**TOWN OF NEWBURGH
PLANNING BOARD
TECHNICAL REVIEW COMMENTS**

PROJECT NAME: DUNKIN DONUTS
PROJECT NO.: 14-02
PROJECT LOCATION: SECTION 14, BLOCK. 1, LOT 43
REVIEW DATE: 13 MARCH 2015
MEETING DATE: 19 MARCH 2015
REPRESENTATIVE: JOSEPH MINUTA

1 Typical New Pavement Section
S-3 Scale: 1" = 1'-0"

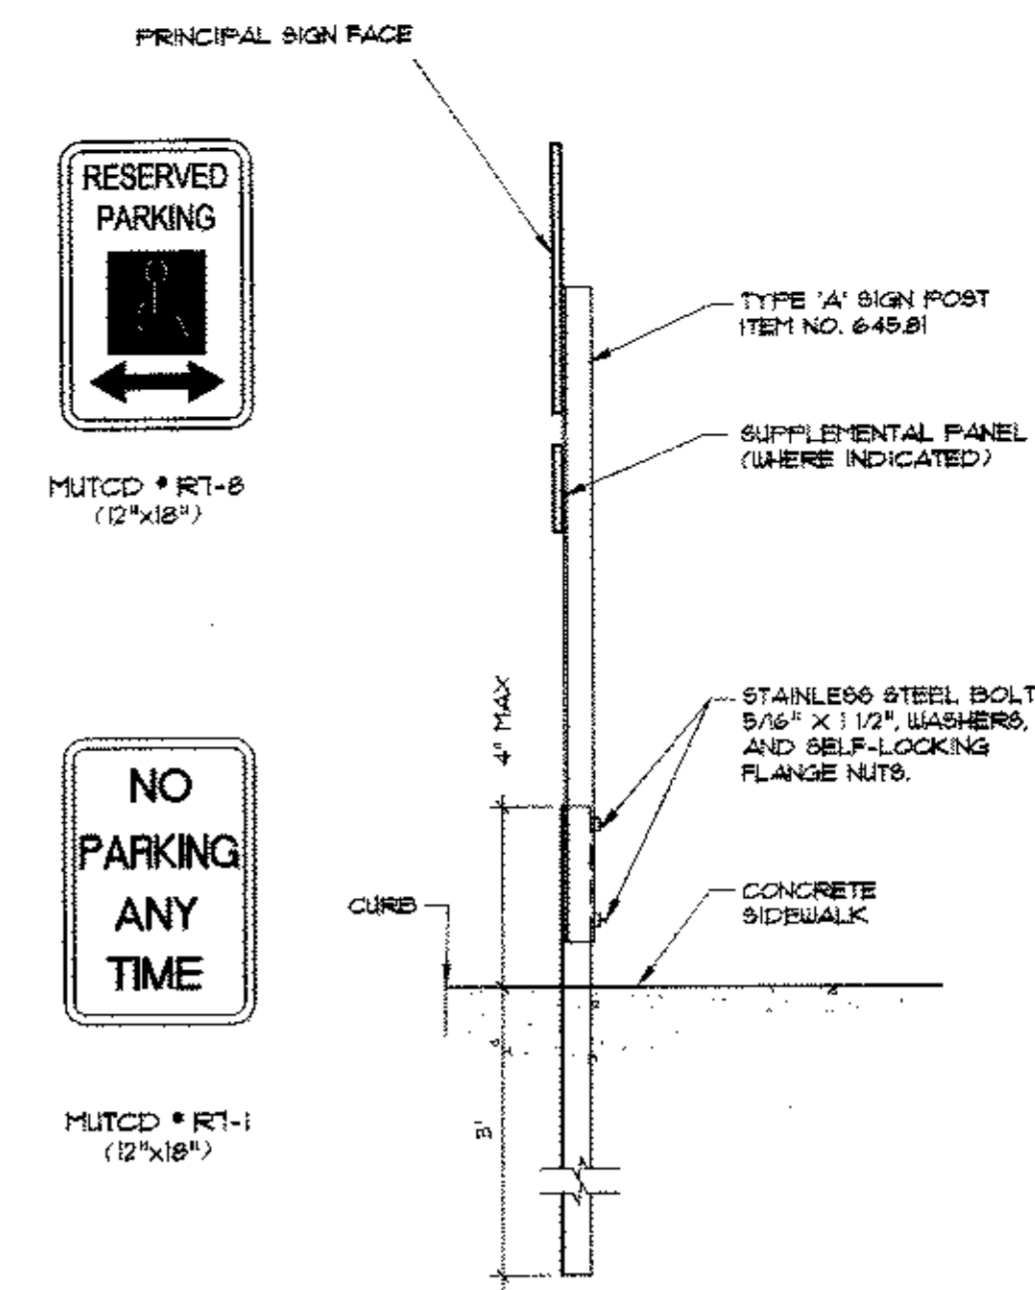
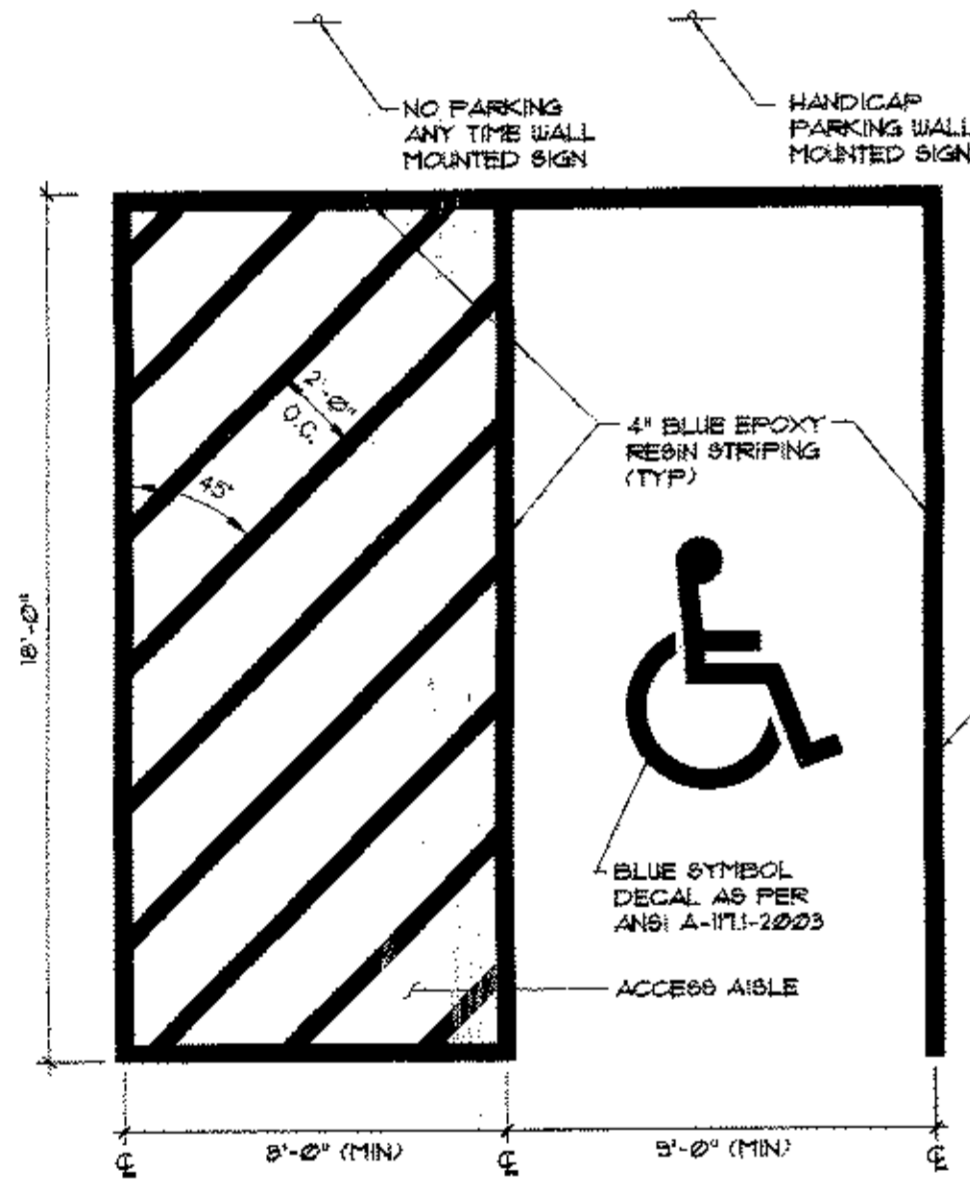
9. It is noted that the new parking area will be milled and overlaid with a new pavement where existing asphalt is located on the site. A small portion of new asphalt section will be placed for the northerly most parking expansion. Entire parking lot will then be restriped with new compliant striping.

7 Typical Fieldstone Wall Detail
S-3 Scale: N.T.S.

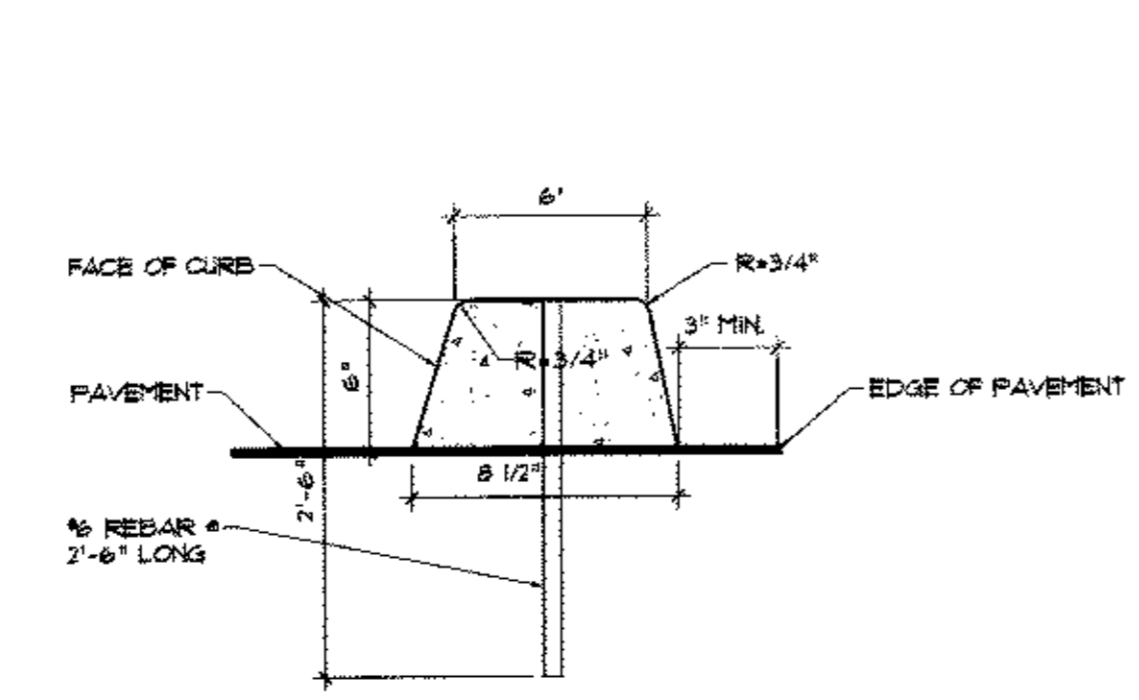
8. Parking in front yard is identified on the plan based on existing lot geometry and building location. A dry laid stone wall is identified on the plan as a mitigation measure. Planning Board should confirm acceptability of the stone wall screening mitigation.

1 Dry Pipe System Schematic
S-6 Scale: N.T.S.

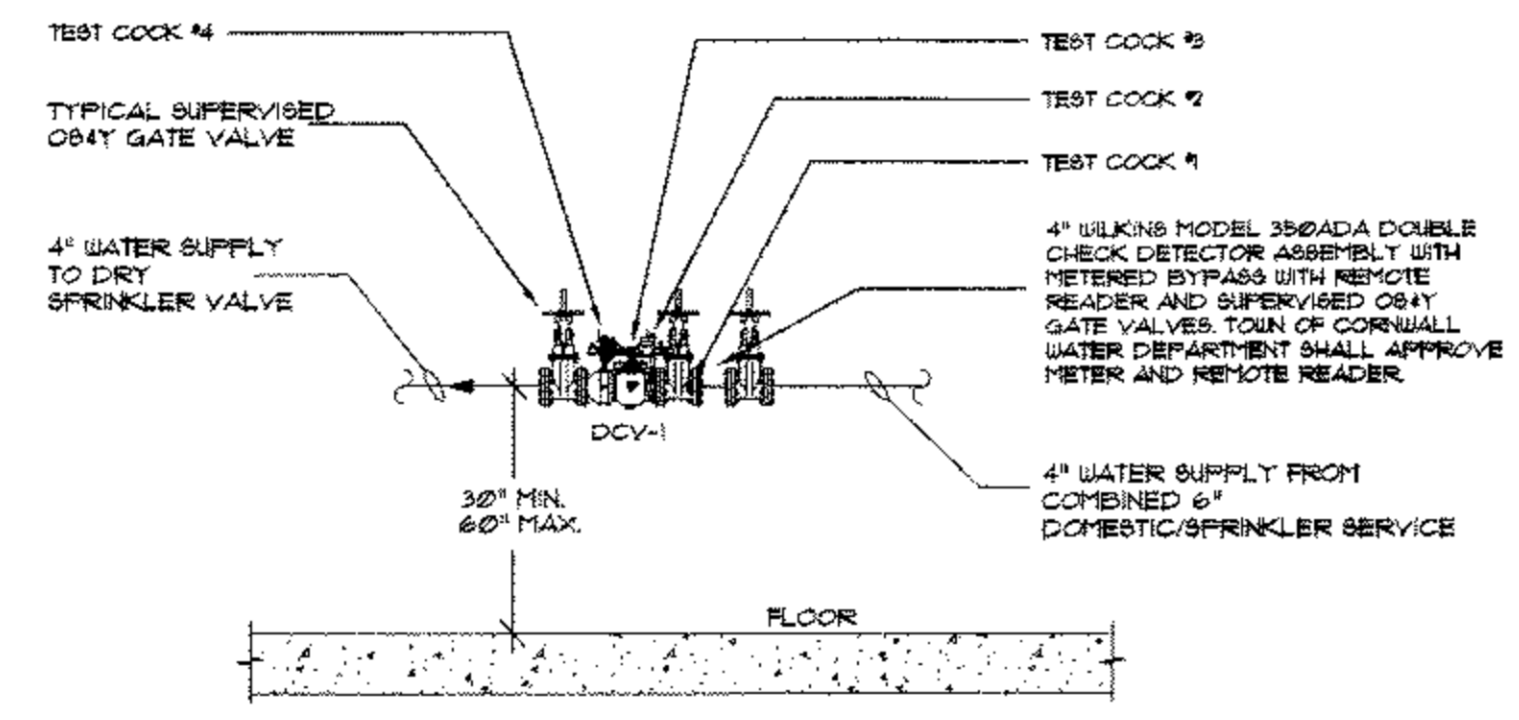
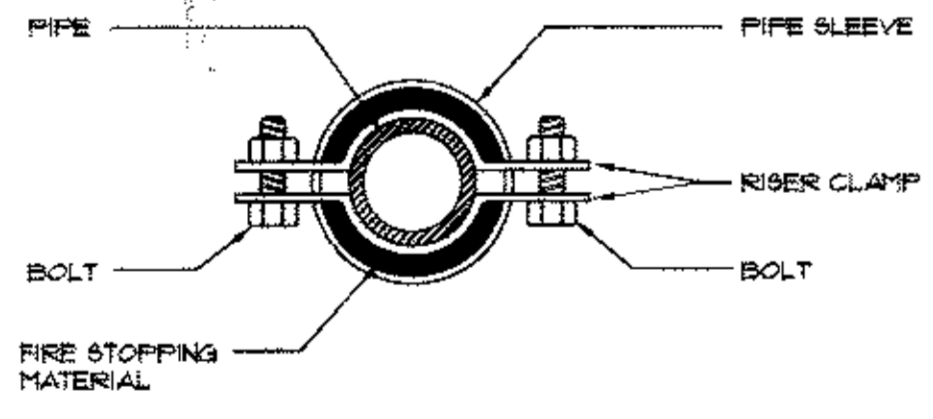
4. Revised Town of Newburgh Water System Notes should be added to the plans. (2015 version provided).
5. Building is proposed to be sprinklered. Sprinkler and potable water supply should be laid out in compliance with Town of Newburgh regulations whereby valves for sprinkler system are on the water main side of the valve for the potable water such that potable water is terminated when sprinkler supply is terminated.

1 Proposed Site Lighting Plan
 L-1 Scale: 1" = 20'-0"

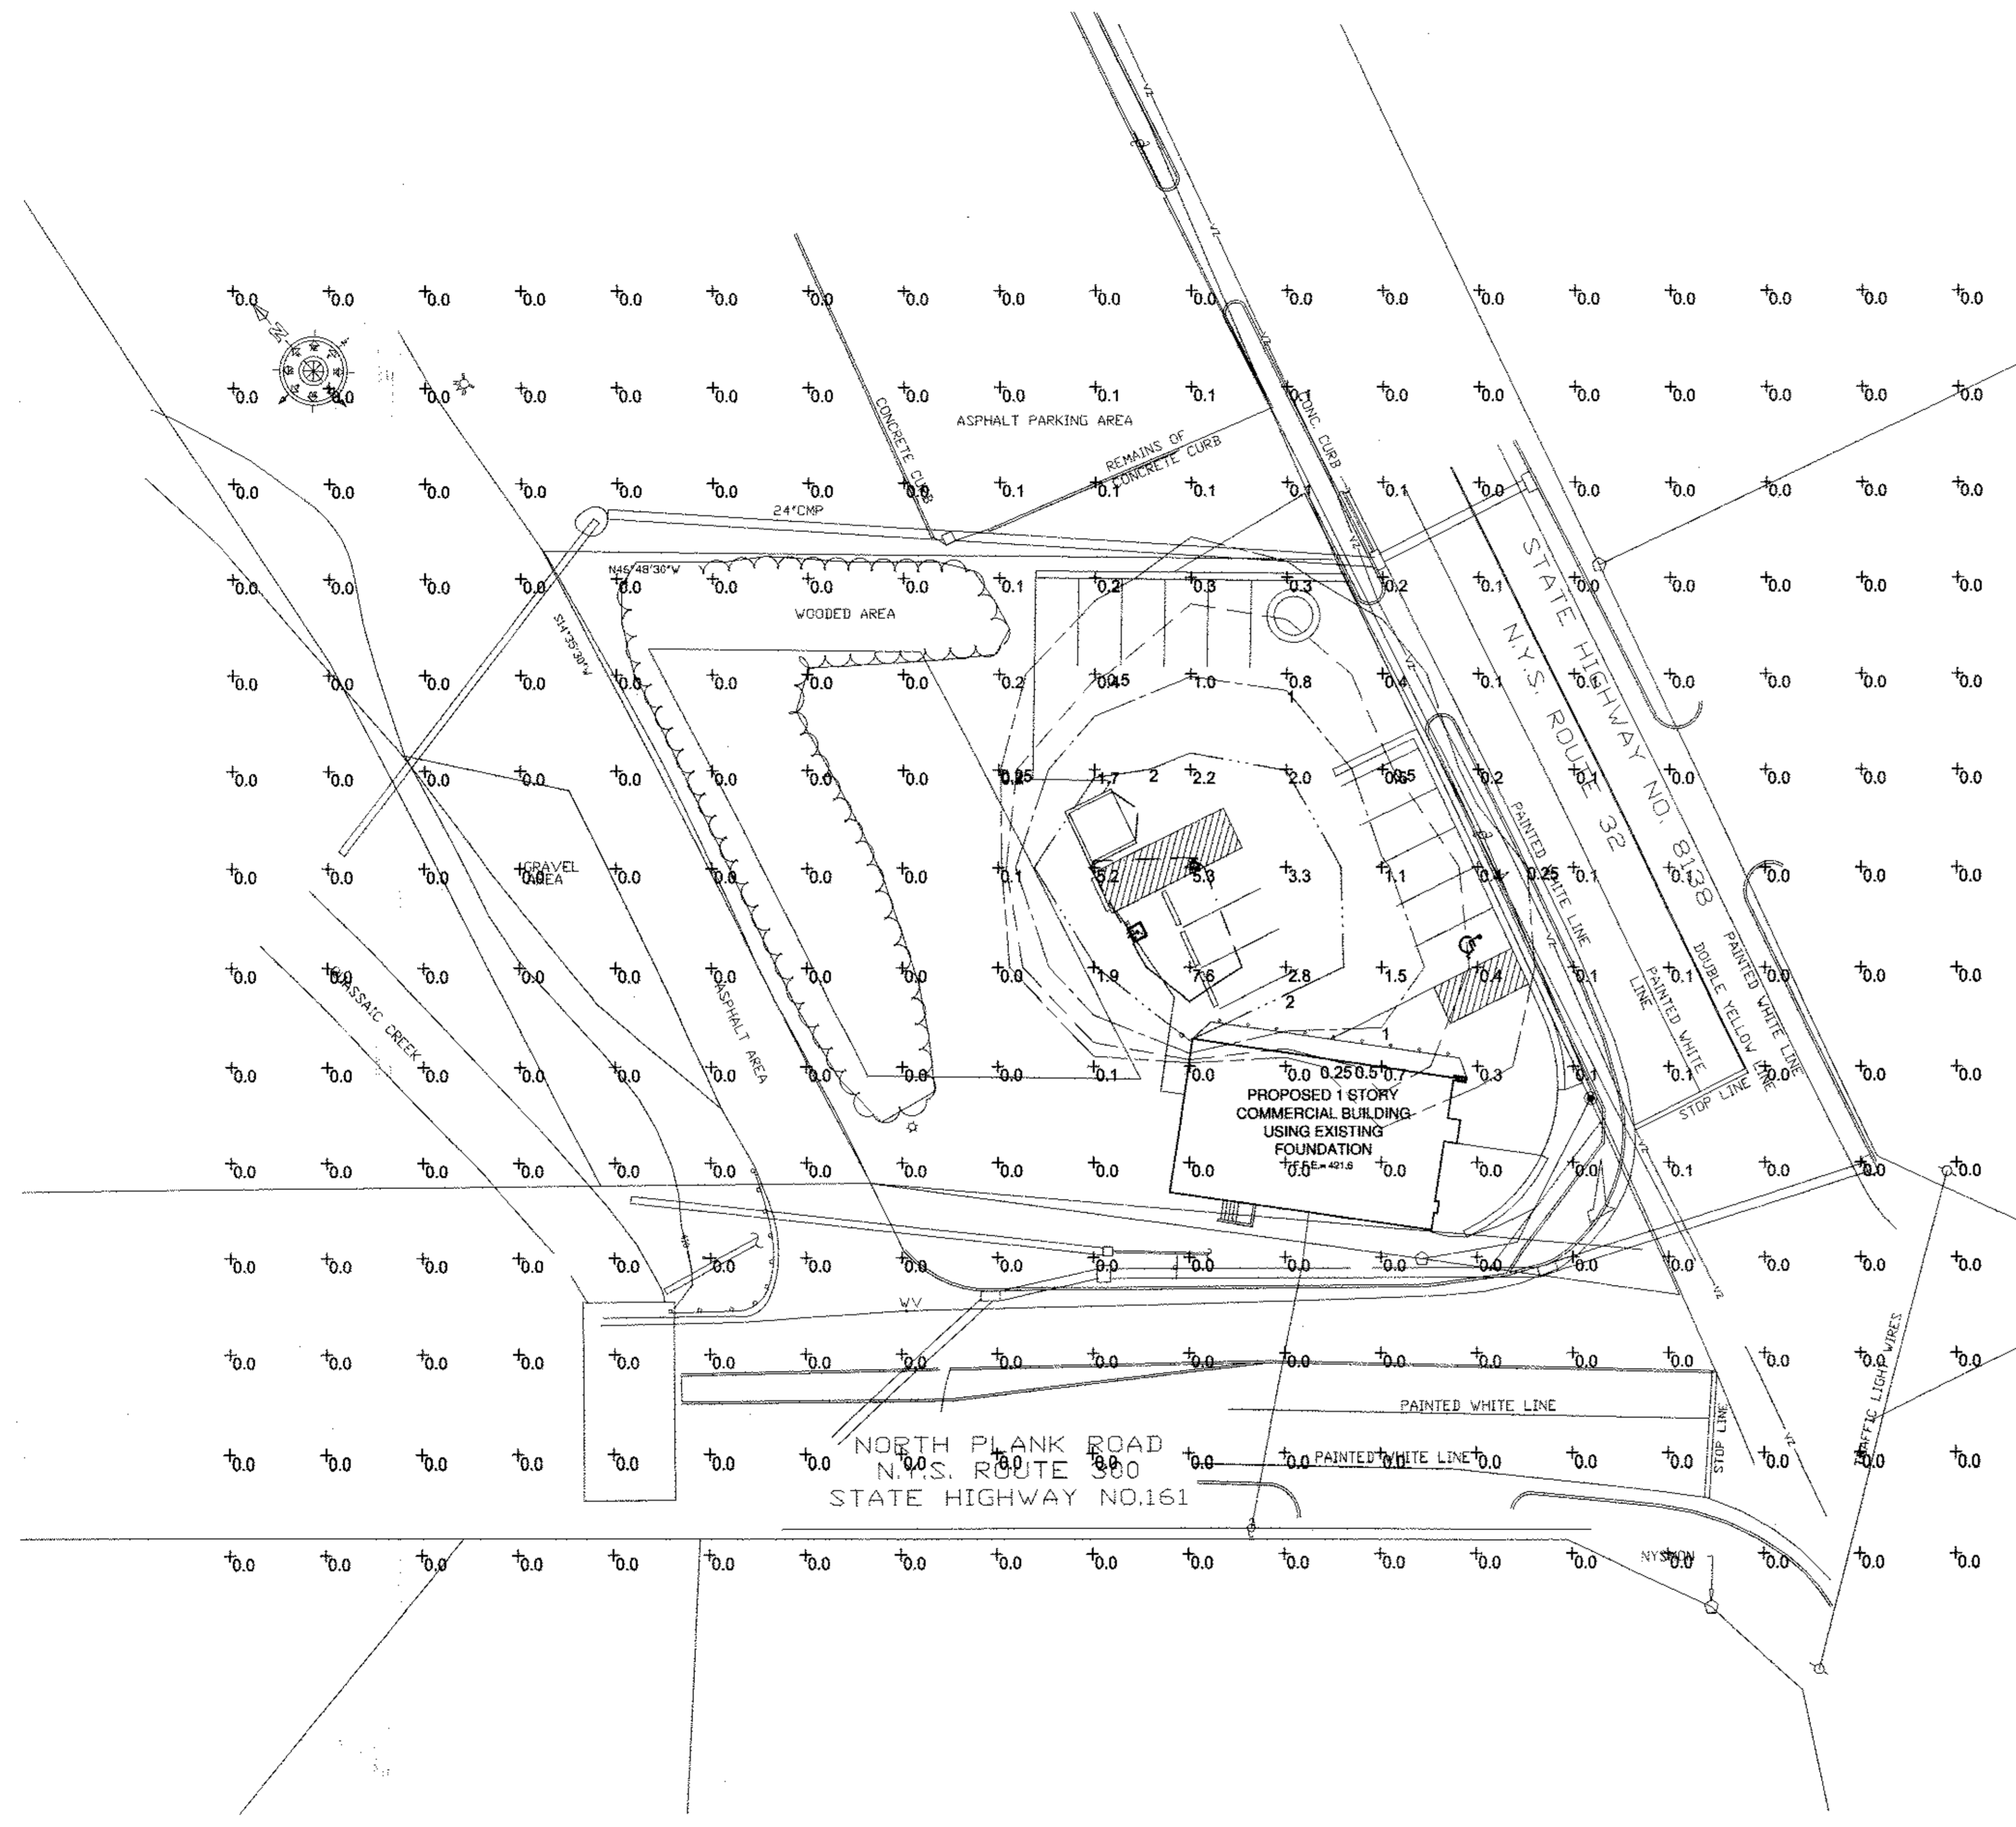
7. The Planning Board should review the lighting fixtures proposed. A 20.5 foot light fixture is proposed in more pedestrian scale lighting may be called for on the small site. Design guidelines identify 16 foot maximum height lighting for such a site. The change may require an additional light fixture on the site. Currently one 20.5 foot light fixture is proposed.
